ENGINE – FUEL AND CONTROL – INTRODUCE NEW FUEL PUMP TO FUEL COOLED OIL COOLER TUBES  
WITH A REPOSITIONED RESTRICTOR ORIFICE – CATEGORY CODE 7 – MOD.ENG-73-0063

V2500-ENG-73-0063

SCHEMATIC VIEW OF FUEL TUBES  
BEFORE ALTERATIONSchematic view of fuel tubes - Before and after alteration  
Fig.2

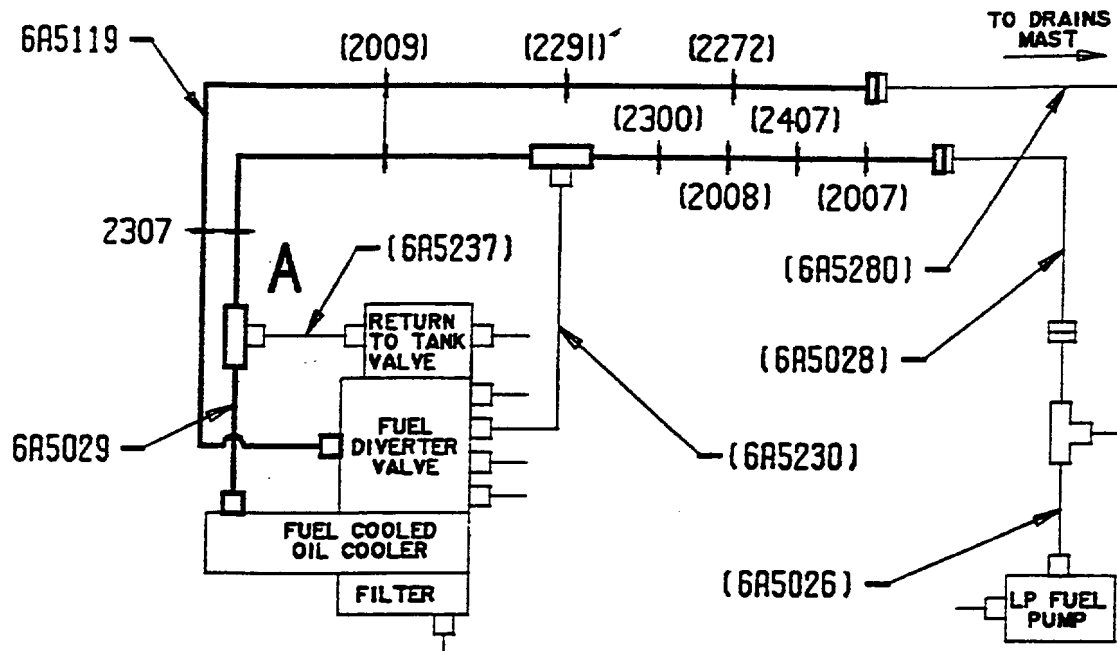
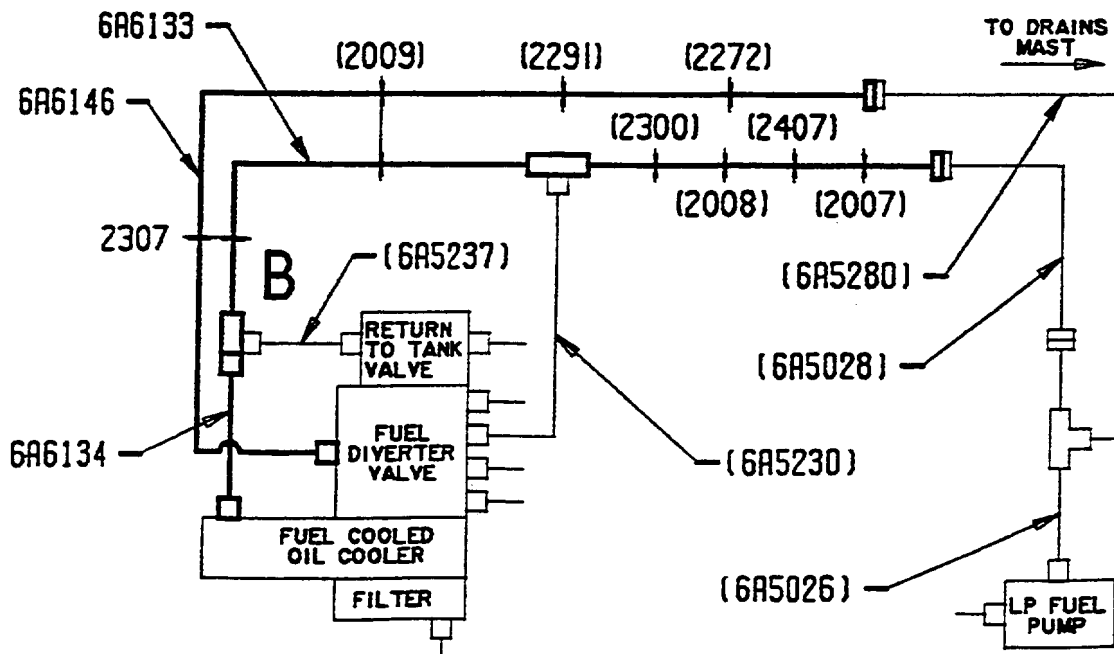
The existing LP fuel pump to FCOC fuel inlet tube assembly is replaced by two tube assemblies. The first tube runs from the L.P. fuel pump to the connector for the return to tank valve and the second tube runs from this connector to the FCOC fuel inlet. The fuel flow restrictor has been redesigned to prevent incorrect assembly and its location changed from the FCOC inlet end of the existing tube to the return to tank valve tube connector end of the new FCOC fuel inlet tube. The existing fuel diverter valve drain to disconnect tube has also been re-run to accommodate the new fuel tubes. Clip Point 2307 has been modified to suit the new fuel diverter valve drain to disconnect tube.

- (1) Refer to V2500 Engine Manual for removal instructions (Refer to M.).
- (2) Install a new AS43013-124 sealing ring, lubricated with CoMat 10-038 Petroleum Jelly or CoMat 10-060 Liquid Paraffin, on to the new 6A6133 fuel tube. Connect the 6A6133 fuel tube to the 6A5028 fuel tube using the existing bolts and nuts. Torque the nuts to 85 to 105 lbfin (10 to 12 Nm). Refer to Figures 1 and 2.

- (3) Connect the 6A5237 fuel tube to the 6A6133 fuel tube using the union nut of the 6A5237 tube. Torque the union nut to 566 to 611 lbfin (64 to 69 Nm). Safety the union nut with CoMat 02-119 lockwire. Refer to Figures 1 and 2.

- (8) Install clipping points 2009, 2291, 2300, 2272, 2008, 2407 and 2007 on to the new 6A6133 and 6A6146 fuel tubes using the existing material. Torque the bolt at each clipping point to 36 to 45 lbfin (4 to 5 Nm). Refer to Figure 2.

View at A (see Figure 2) - Before alteration  
Fig.3

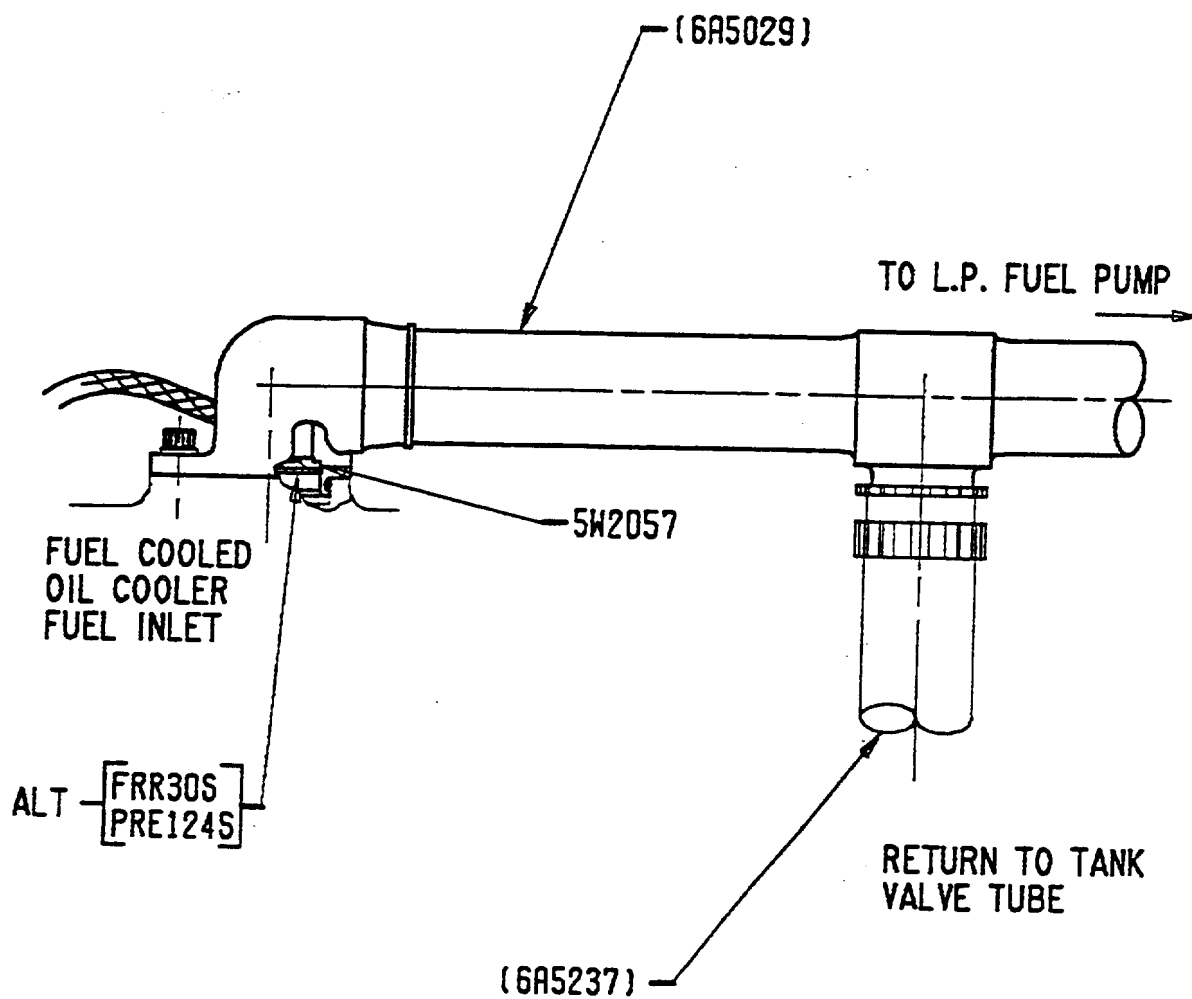
Experience with a similar engine type has indicated that under extreme circumstances erosion of the FCOC matrix can result in oil contamination of the fuel system. In addition the fuel flow restrictor at the inlet to the FCOC can currently be fitted incorrectly.

Flow visualisation testing of the FCOC has indicted that matrix erosion is caused by direct impingement of fuel borne foreign objects such as wires and metal chips, due to the close proximity of the fuel flow restrictor.

View at B (see Figure 2) - After alteration  
Fig.4

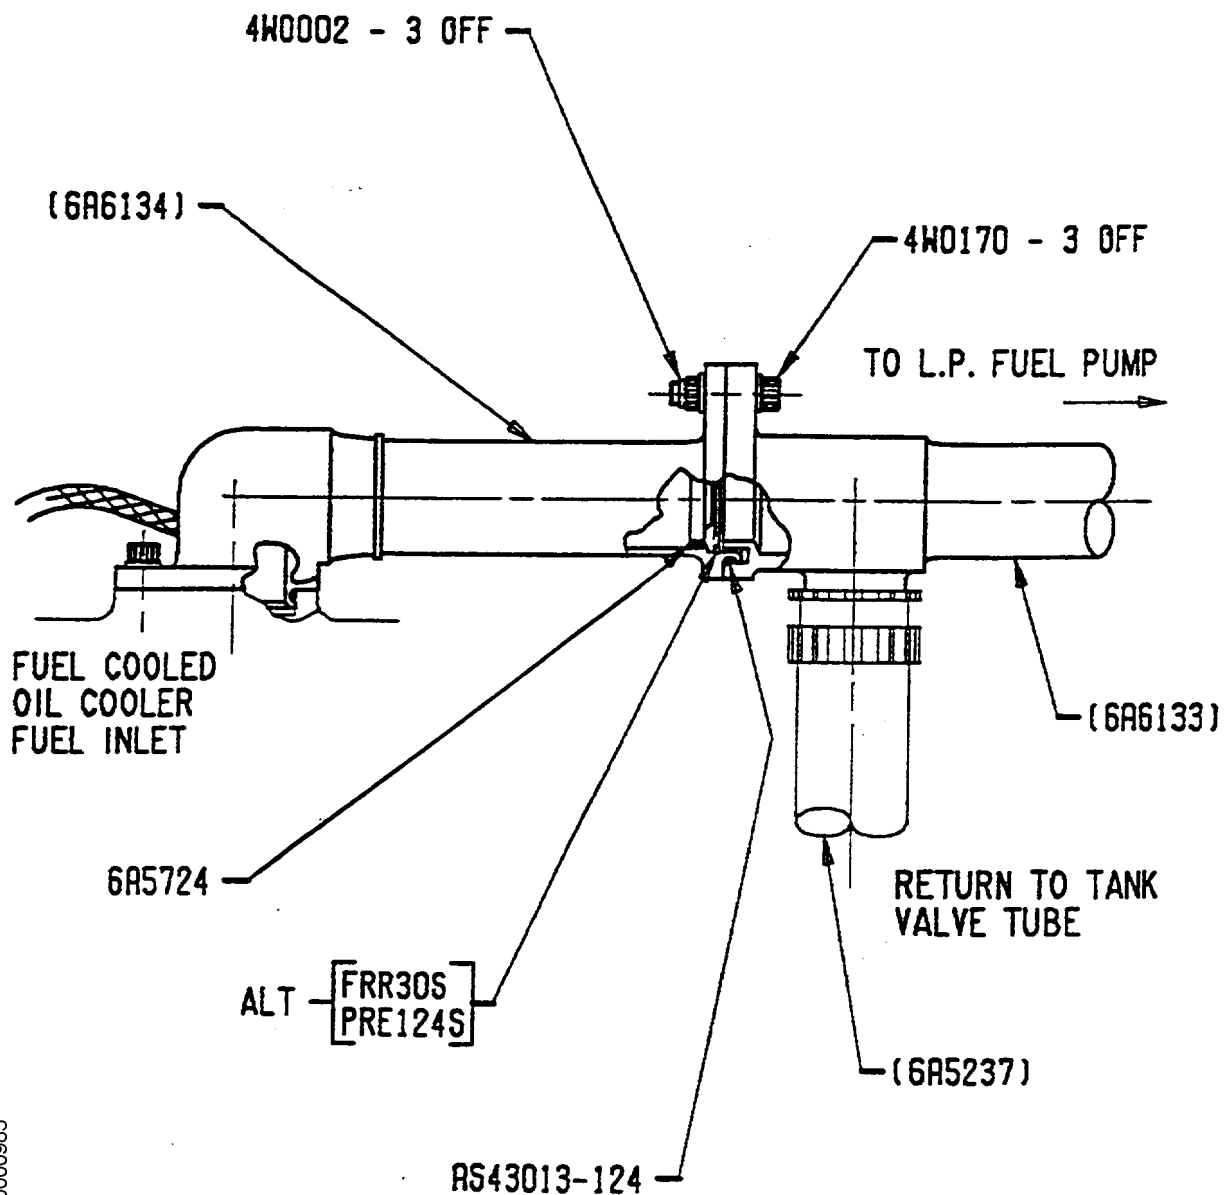
Rig test have established that the new position of the fuel flow restrictor will alleviate the effects of direct debris impingement on the FCOC matrix. The addition of spigots on the pipe end connector and the fuel flow restrictor ensures against incorrect fitment.

- (4) Install a new AS43013-124 sealing ring, lubricated with CoMat 10-038 Petroleum Jelly or CoMat 10-060 Liquid Paraffin, on to each end of the new 6A6134 fuel tube. Connect the 6A6134 fuel tube to the 6A6133 fuel tube using the three 4W0170 bolts and three 4W0002 nuts. Torque the nuts to 85 to 105 lbfin (10 to 12 Nm). Refer to Figure 4.
